**CERTIFICATE OF JUMPING HILL
CERTIFICAT DE CONFORMITE
SCHANZENPROFILBESTÄTIGUNG**

Place: Planica

Name: Letalnica "Bratov Gorisek"

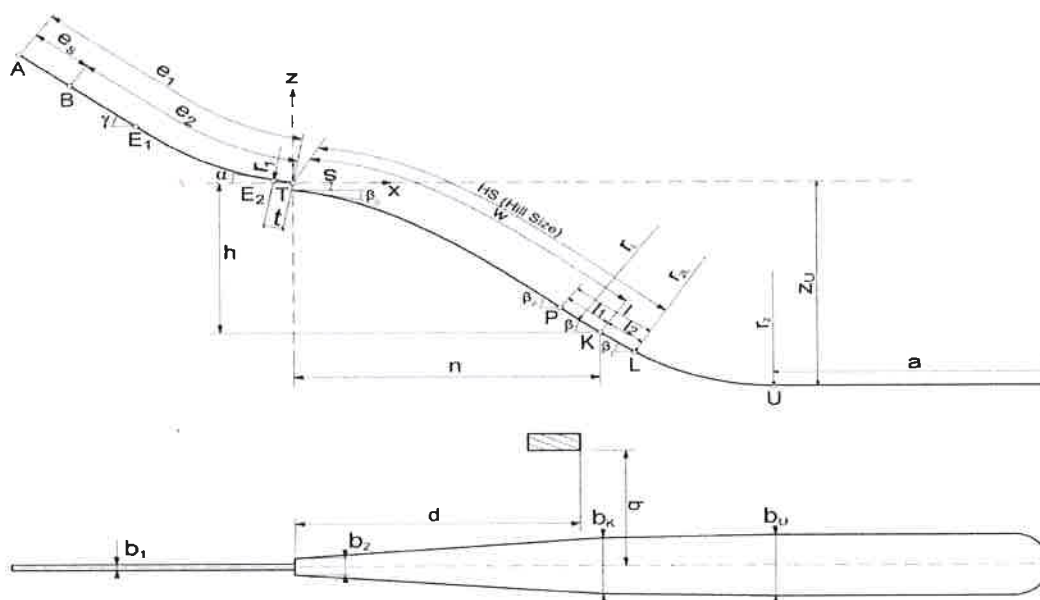
- inspection by Richard Kaiser (2nd March 2015)
- remarks of inspection-report from 2nd March 2015 must be observed.
- snow-profil of hill = 1,0m vertical down from the top of guard-rail
- markings of table; K; HS; U fixed in concrete and dokumented by surveyor and inspection-report
- *) β_L parameter must be exactly checked and perhaps corrected.
